Vermont Agency of Transportation
RECEIVED
CK'D BY GL, RK, JG OK'D BY JS
January 27, 2014
RESUBMIT YES Rejected
BY KH DATE 2-18-2014

Fire Drive off VT Rte. 30
VAOT #ER-BRF 015-1(23)
Jamaica, VT
16'x8' Box Culvert - Layout & Profile

△ 1 S1.0 CULVERT LAYOUT PLAN VIEW

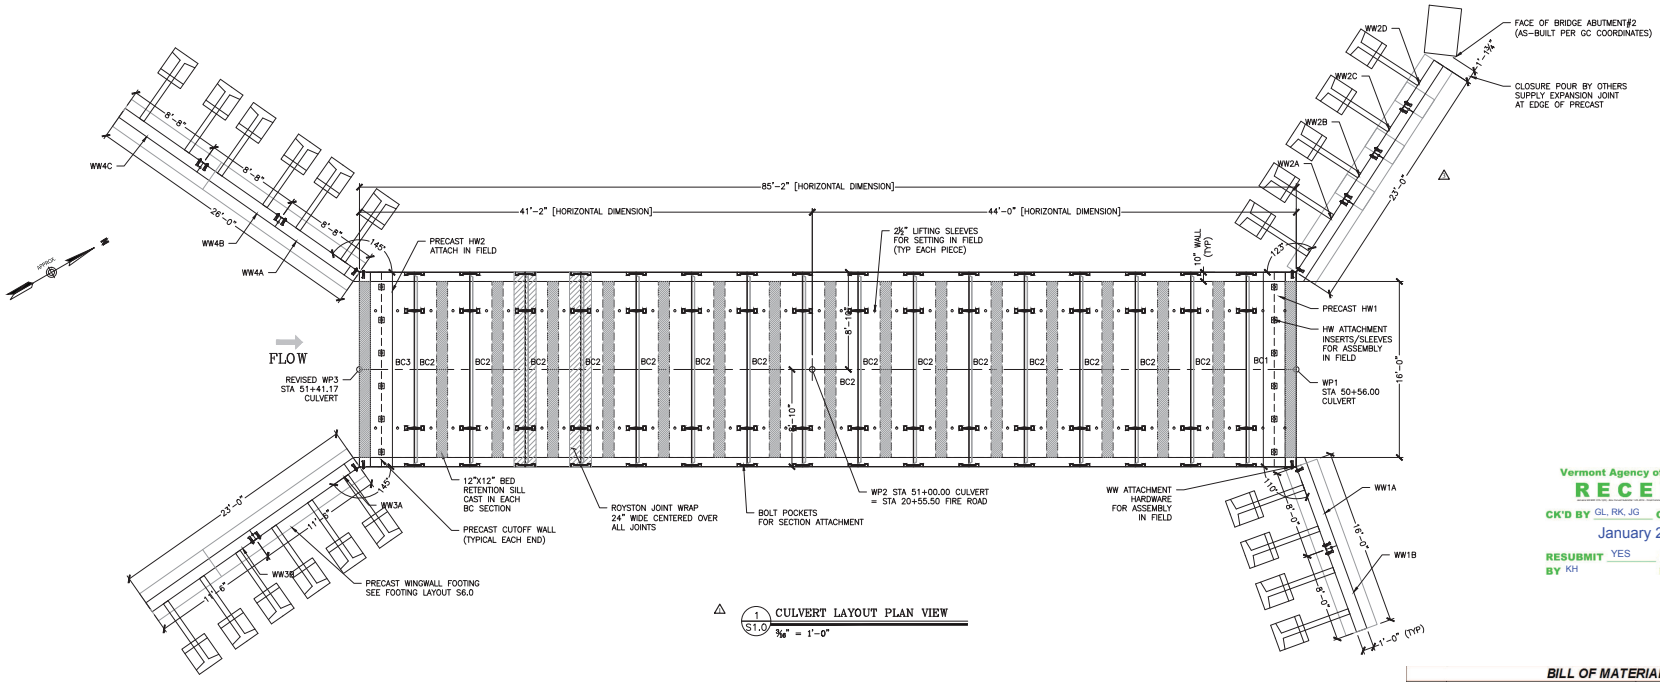
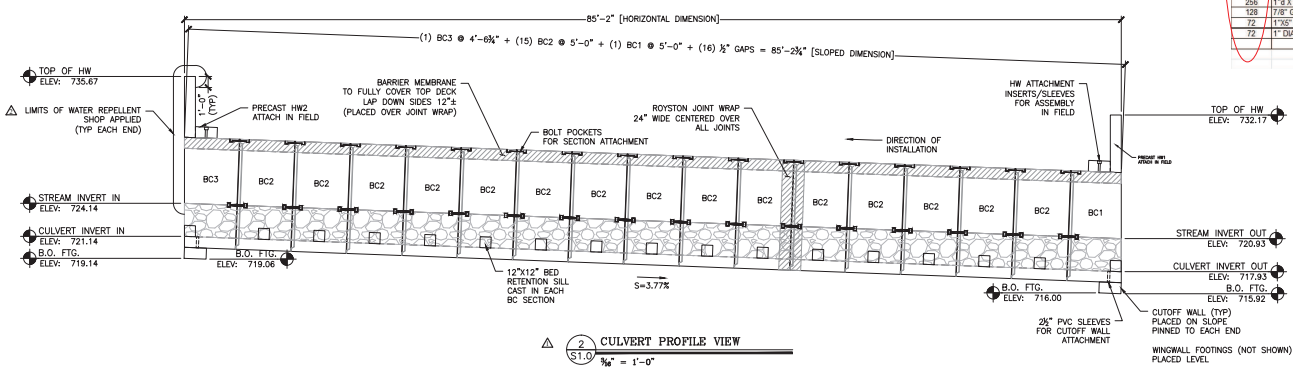
VERIFY QUANTITIES. QUANTITES ARE THE SAME AS PRIOR SUBMITTAL. THERE SHOULD BE ADDITIONAL ANCHORS, ETC REQUIRED FOR WW#2 CHANGE?

1 WW2 PLAN VIEW
511.0 ½" = 1'-0"

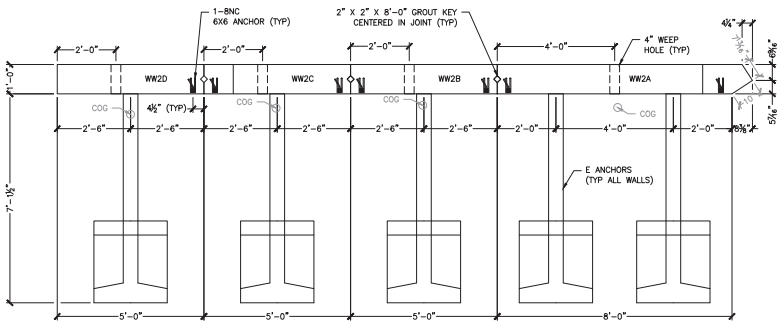
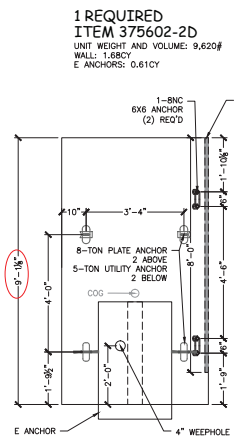
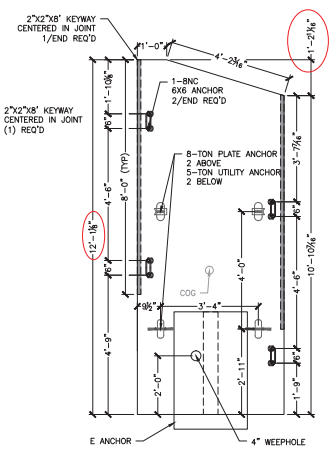
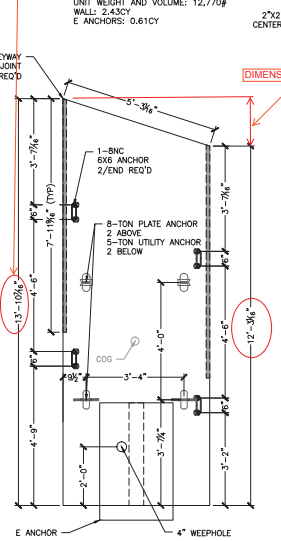
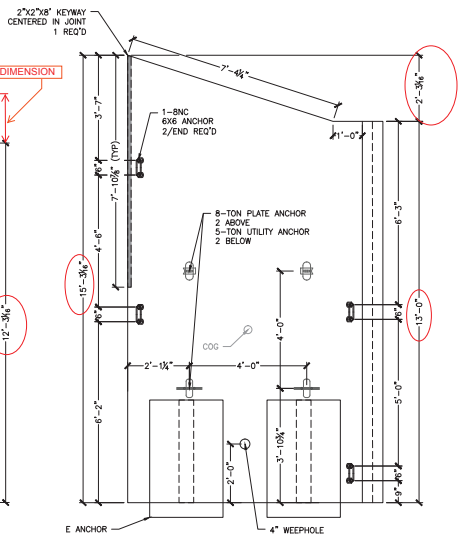
PROVIDE CONNECTIONS OUT OF THE WINGWALL INTO THE CLOSURE POUR FOR REINFORCING STEEL

PROPOSED DIMENSIONS DO NOT SEEM TO TRANSITION SMOOTHLY ACCROSS THE SLOPE. VERIFY ALL.
